SUBJECT: GENERIC FUNDAMENTALS EXAMINATION RESULTS

# FACILITY COMMENTS AND NRC RESPONSES FOR THE OCTOBER 1996 GFE

## FACILITY -- WATERFORD

### EXAM -- PWR FORM A/B

#### QUESTION: 14/42

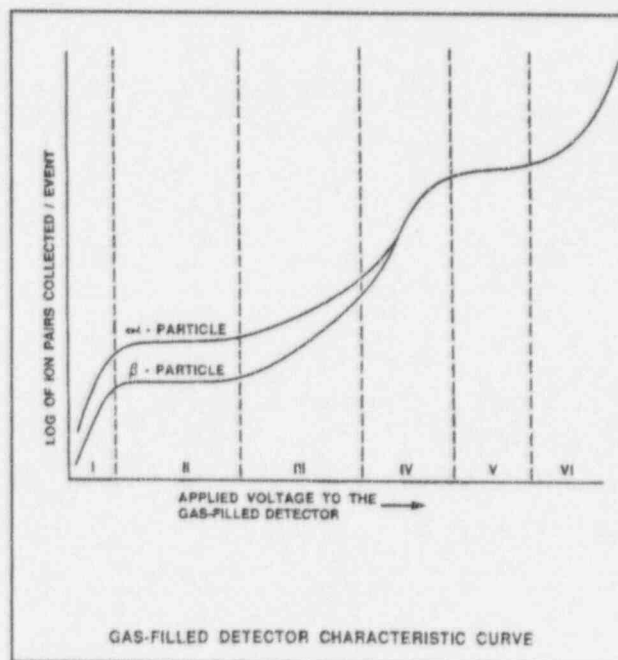
Question 14, in our opinion, is testing at a level equivalent to that which would be expected knowledge for a maintenance technician specializing in radiation instrumentation.

Do not concur. This question is supported by NRC generic component K/A 191002K118, "Theory and operation of ion chambers,..." According to Westinghouse (Radiation, Chemistry, and Corrosion Considerations for Nuclear Power Plant Application, 1983, p. 5-29), "In a high gamma field with high operating voltage, gamma pulse pile-up results in instrument output indicating a neutron flux much higher than actually exists." This makes option B the correct answer.

Based on the interim answer key, this question was answered correctly by 23/124 examinees and yielded a very small positive discrimination index of +0.02. No answer key change is required.
